***The CITADEL***  
***Summerall Chapel Stained Glass Restoration 2025***  
***Project H09-N186-ML***

***ADDENDUM #2***  
***To Bid Documents dated September 17, 2024***  
***October 8, 2024***

INTERIOR VENTED SYSTEM  
SUMMERALL CHAPEL

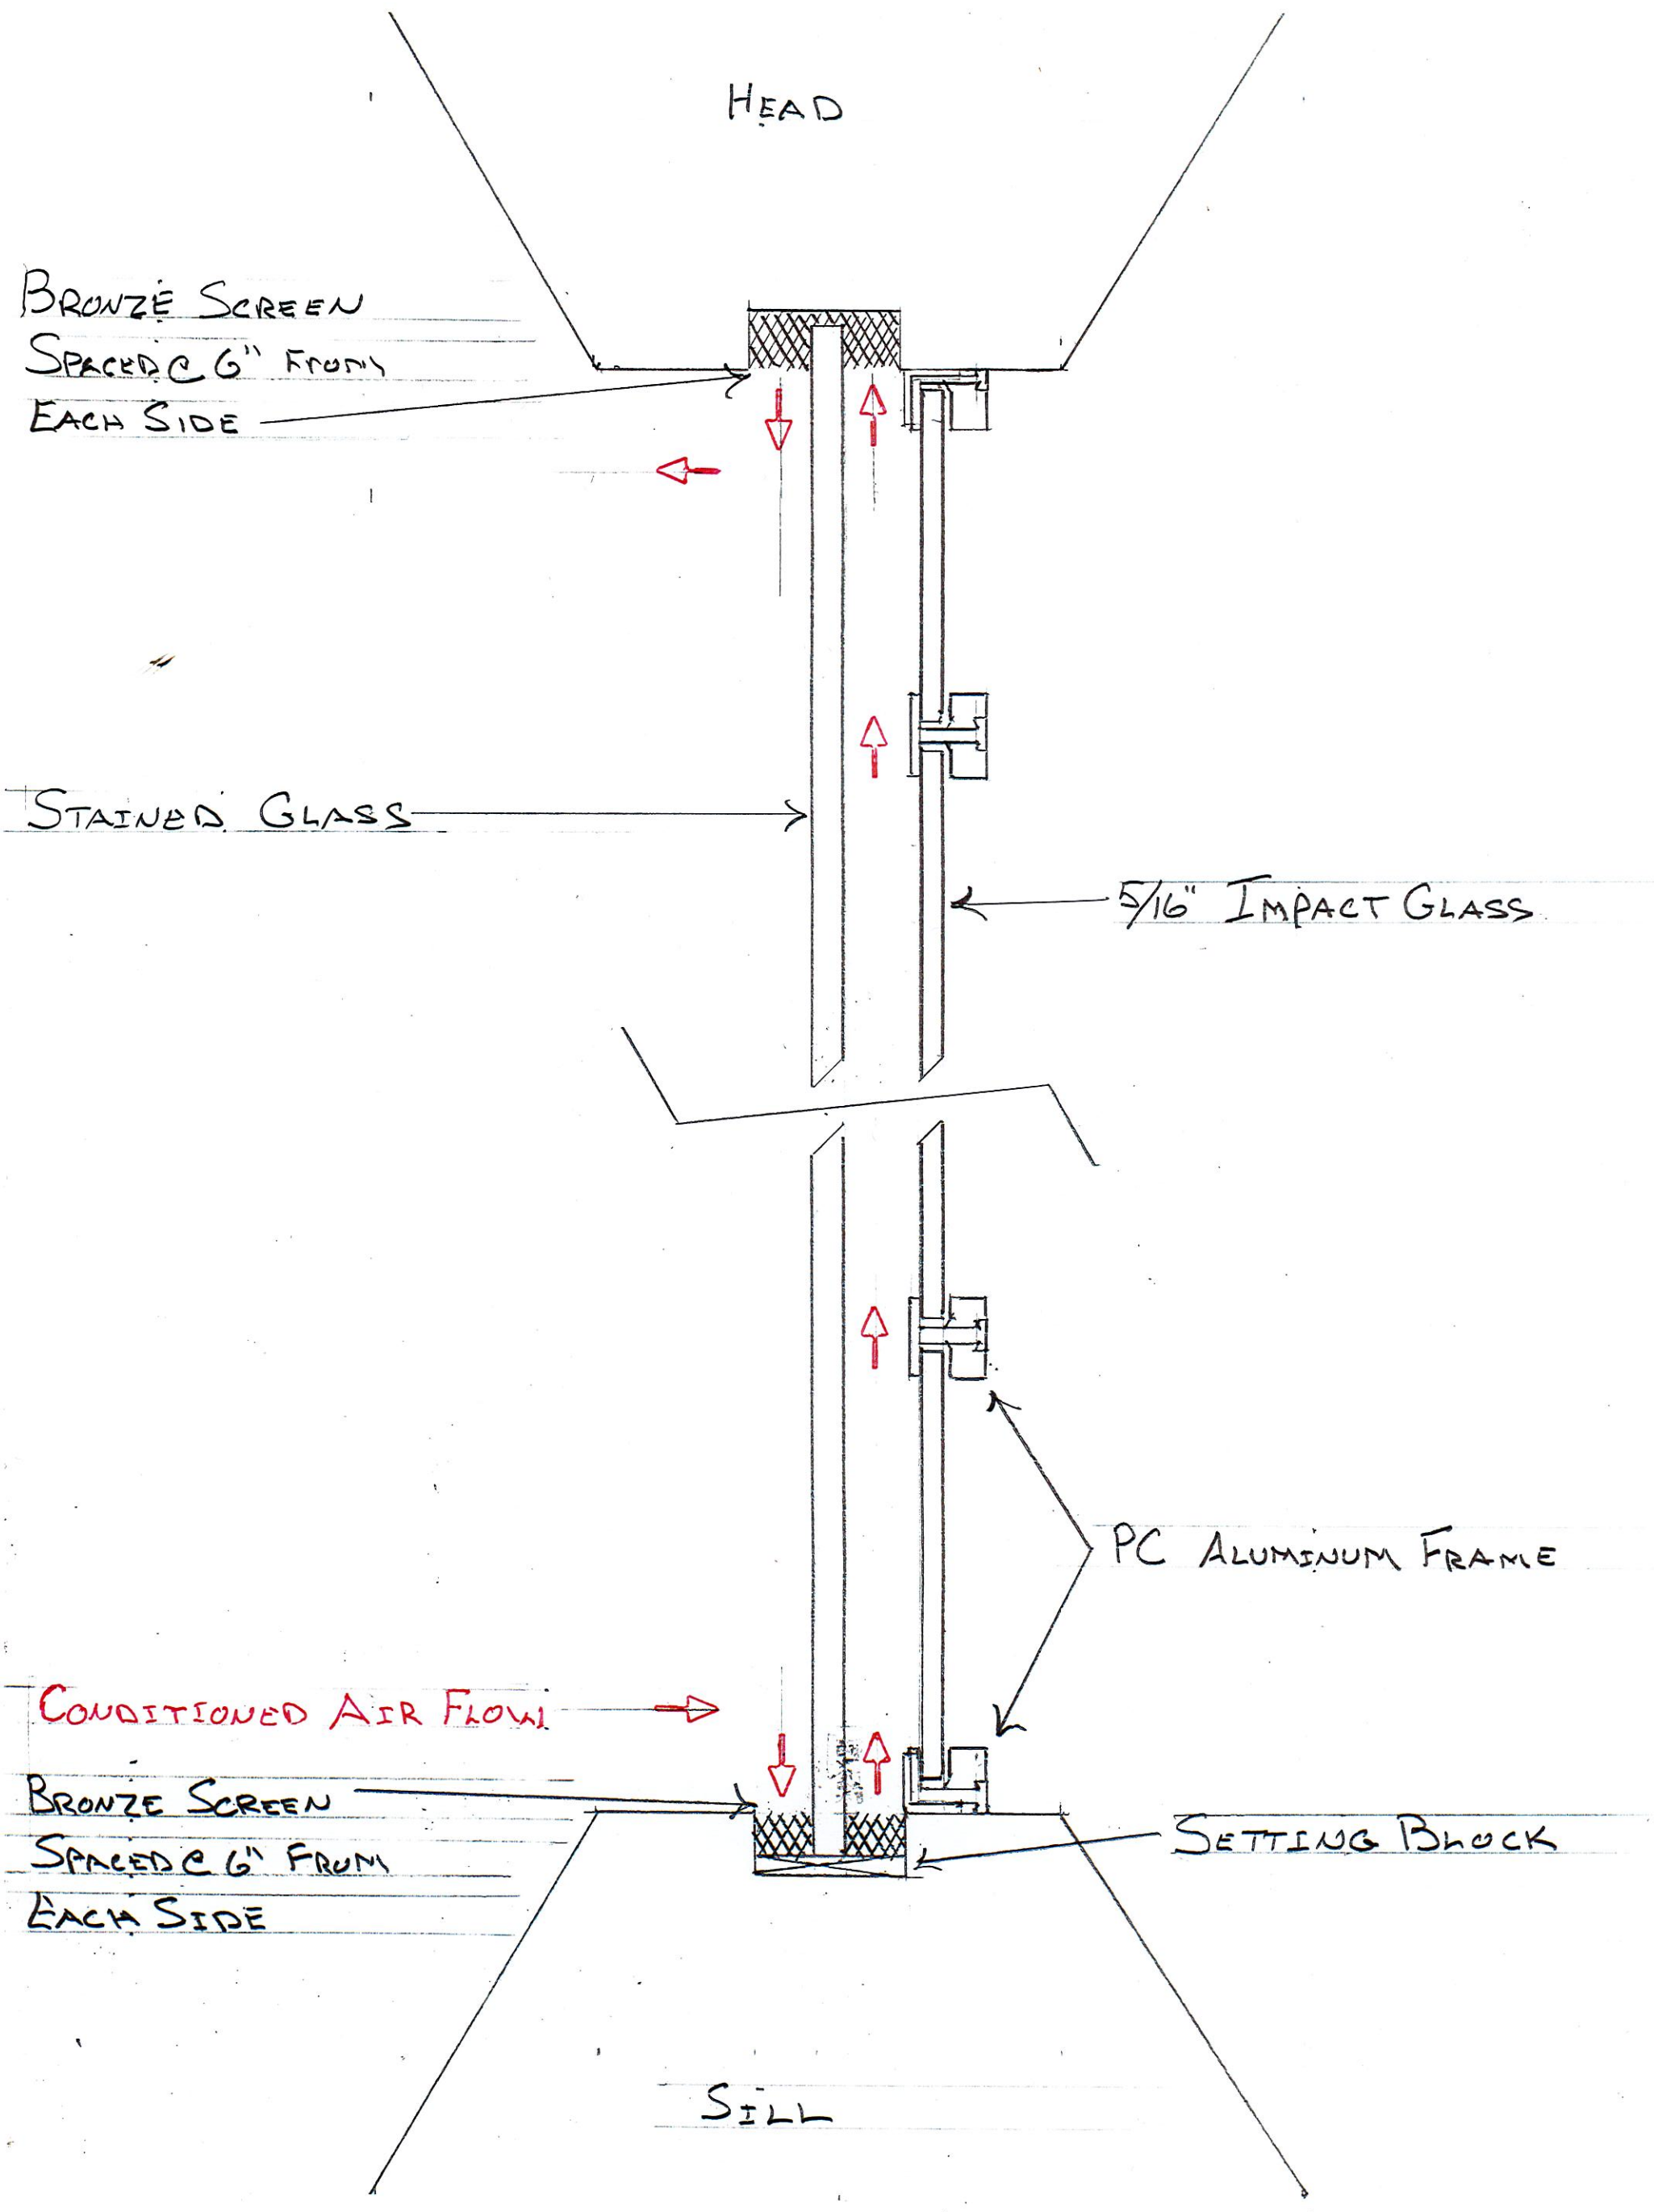
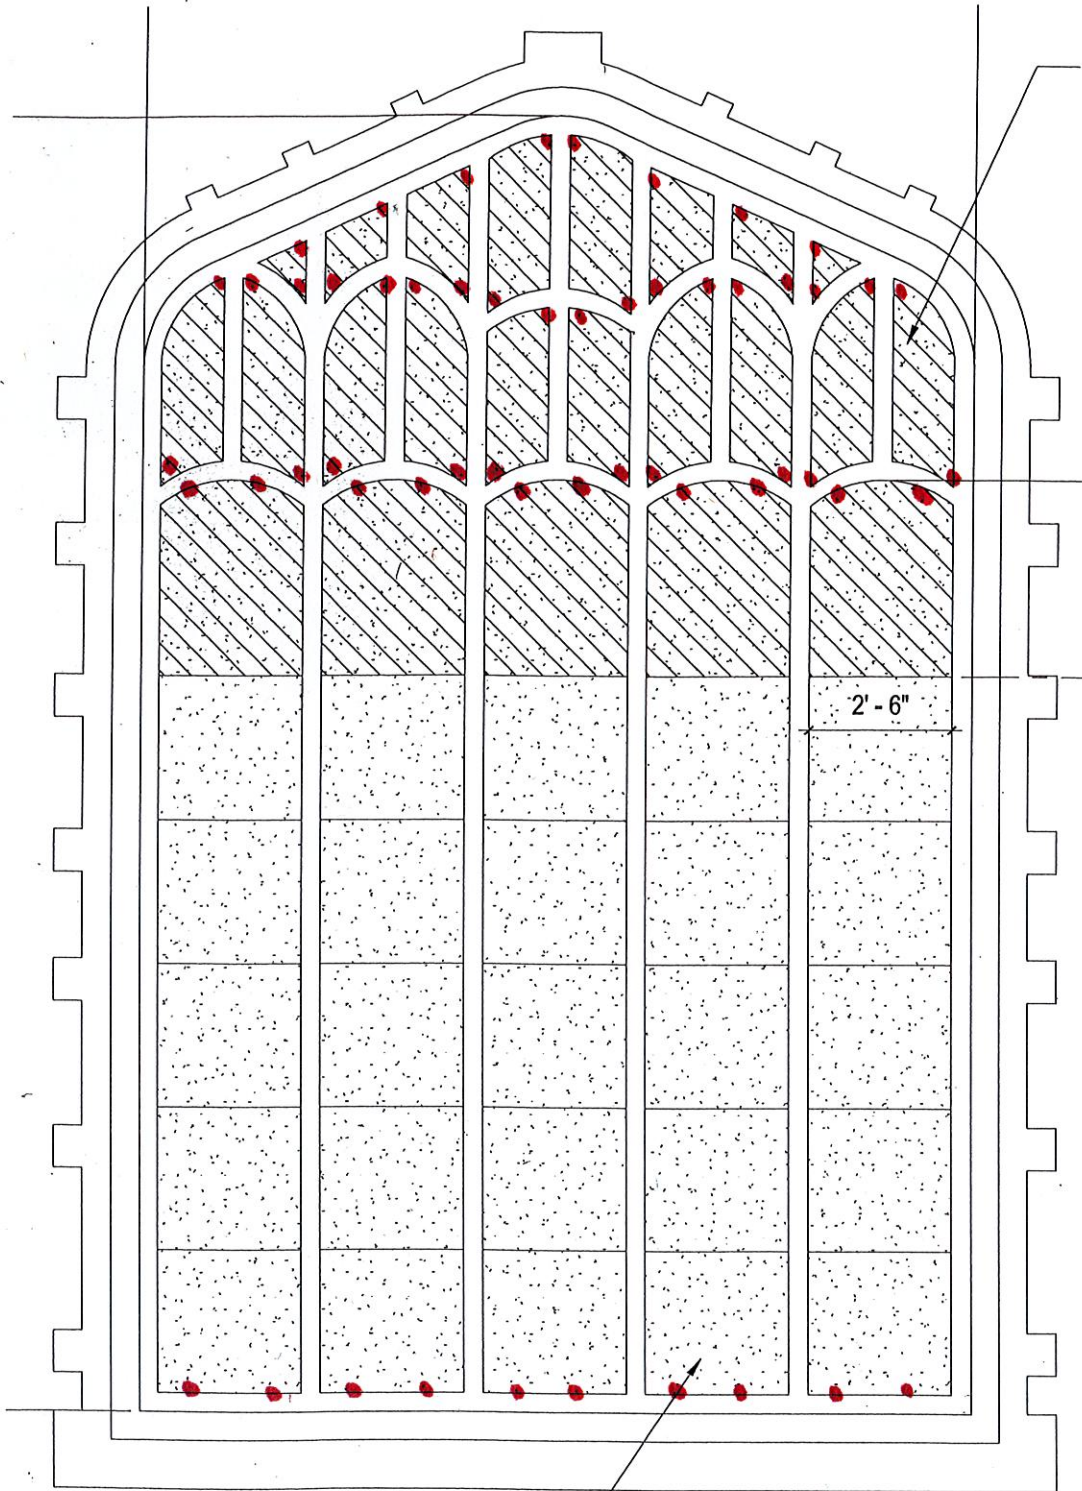
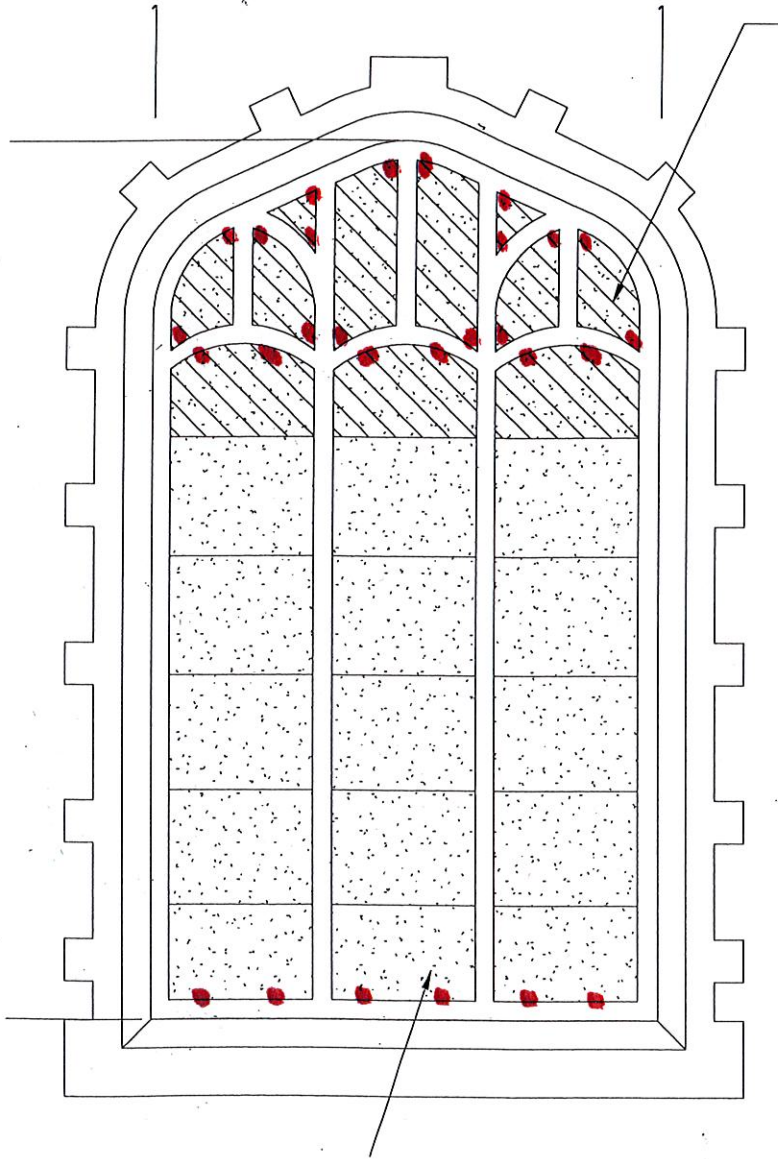
2. QUESTION – Venting the windows to the interior would allow conditioned air between the two panels and eliminate condensation between the stained glass and the protective covering. In the summer months, if condensation did occur from the extreme hot and humid weather, the condensation would accumulate on the exterior of the protective covering and not between the two surfaces. This would also be less intrusive than venting the extrusions on the exterior. Can this be used? (please see attached).

ANSWER – The proposed interior ventilation system does not appear to address the anticipated condensation on the inside face of the protective covering, or provide a means for internal drainage through weep holes or channels, in the predominantly hot and humid climate of Charleston. The proposed system is not approved for use.
